Service Request No: 505203
File Reference: 1047685
Your Reference: S210167

Request for Further Information Pursuant to Section 92(1) of the Resource Management Act 1991

Service Request Type:	Resource Consent
Site Address:	292 Tawa Road, Tawa
Legal Description:	Lot 1 DP 15312
Consent Type:	Land Use
Consent Description:	Establishment and use of a four story building containing 24 household units

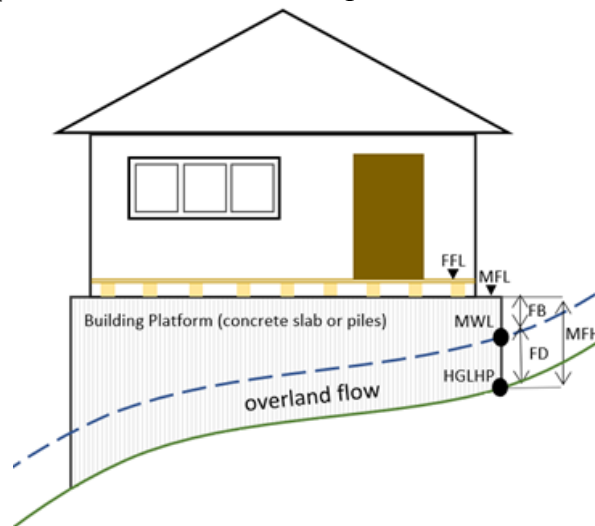
It is recommended that the main access to the apartment building needs to be improved. For example:

- Provide a sheltered threshold
- Include a lobby area that provides adequate space to allow for furniture moving, and people to wait. Include areas for mailboxes and a secure parcel drop
